■INTAKE AND EXHAUST SYSTEM

■ FUEL SYSTEM

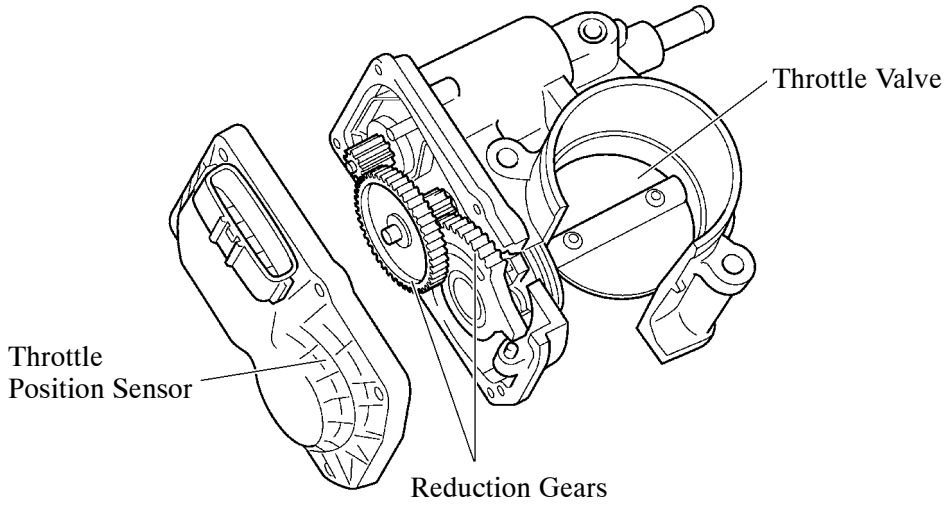
- A newly shaped Air Cleaner Assembly has been adopted.
- A No. 3 Intake Air Resonator has been adopted for the Air pipe Assembly.
- A No. 4 Intake Air Resonator (Intake Air Resonator) has been adopted for the No. 2 Air Cleaner Hose.

New 26T1EG47

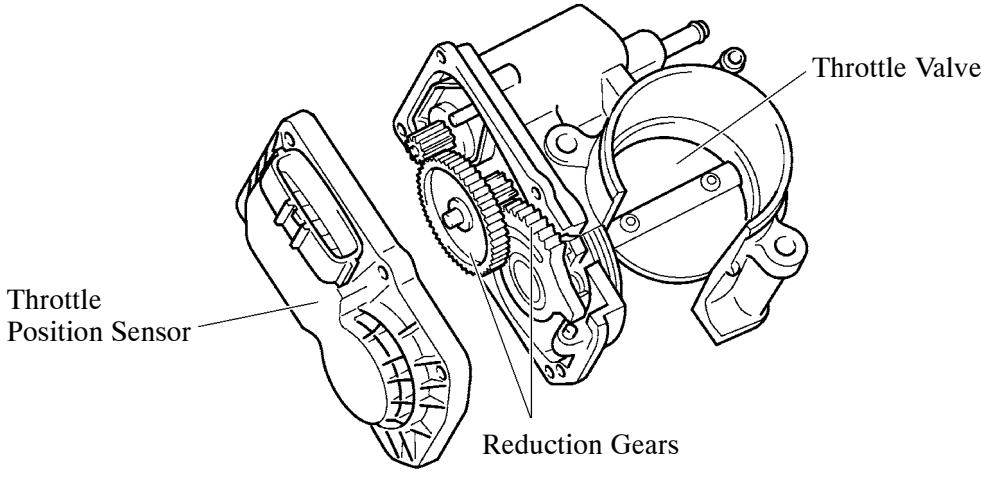
A newly shaped throttle body with motor assembly has been adopted.

26T1EG19D

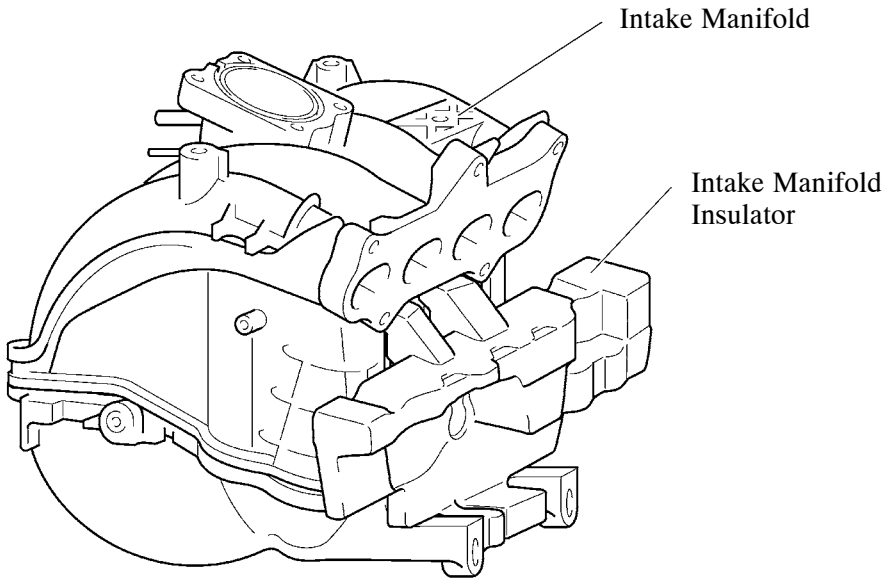
An intake manifold insulator has been adopted for the intake manifold.
